NRC RAI Letter No. PTN-RAI-LTR-041

SRP Section: 02.05.01 - Basic Geologic and Seismic Information

NRC RAI Number: 02.05.01-18 (eRAI 6024)

FPL RESPONSE:

Figure 2.5.1-274 Interpreted Versions of the Southern Half of Profile FS-08 in the Straits of Florida

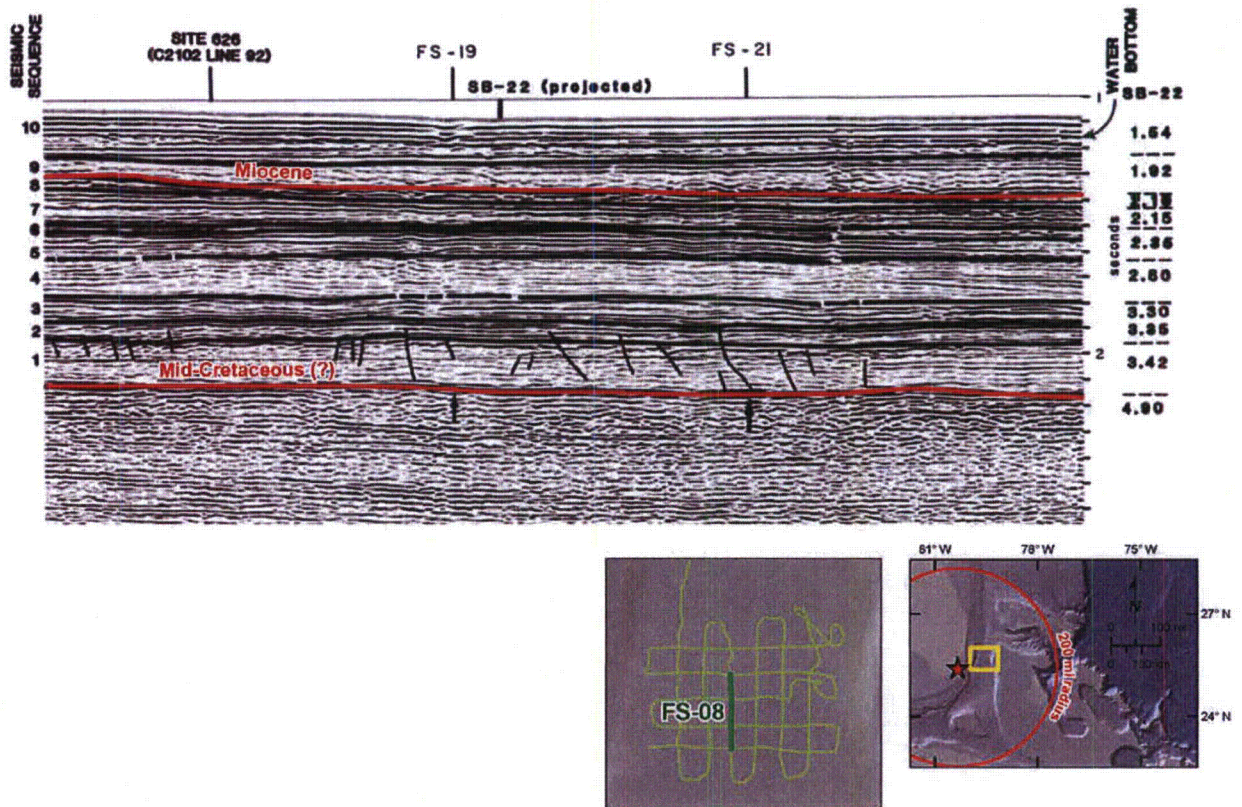
FSAR Figures 2.5.1-274 through 278 and 280, 281, and 287 shows annotated seismic sections, however the staff notes that more information is needed in order to evaluate the relative ages of deformation shown in these seismic cross sections.

In order for the staff to fully understand the regional site geology area and in support of 10 CFR 100.23, please indicate the ages and formation names, if known, of the various sedimentary strata on these figures. Please clarify what is the interpreted depth to faulted strata.

The seismic line in FSAR Figure 2.5.1-274 is from FSAR 2.5.1 Reference 785, hereafter referred to as Austin et al. (1988). Austin et al. (1988) identify 10 prominent seismic sequence boundaries above a mid-Cretaceous (?) target horizon; however, these sequences are not correlated with individual geologic formations. They interpret this target horizon as a buried shallow-water carbonate platform, with an Albian-Cenomanian (mid-Cretaceous) age. Similarly, Sheridan et al. (1981) (FSAR 2.5.1 Reference 424) hypothesize that this platform is mid-Cretaceous in age.

The only age information provided by Austin et al. (1988) for the prominent seismic sequence boundaries above the target horizon is for the 8/9 boundary (upper reflector in Figure 2.5.1-274, Figure 14 from Austin et al. (1988)), which is the only well-sampled part of the section at Site 626. They correlate the debris flows and turbidites sampled there with the Great Abaco Member of the Blake Ridge Formation, which would mean sequence 9 is composed of middle Miocene deposits. Austin et al. (1988) note that consistent fault offset is only seen at the sequence 1/2 boundary. One of these faults is interpreted to almost reach the 2/3 boundary, which lies at a depth of 1.74 kilometers (1.08 miles) beneath sea

level and roughly 940 meters (3080 feet) beneath the seafloor (assuming a mean water depth of 800 meters (2620 feet), see Table 5 and Figure 13 from Austin et al. 1988. This faulting occurred between the deposition of mid-Cretaceous and middle Miocene sequences.
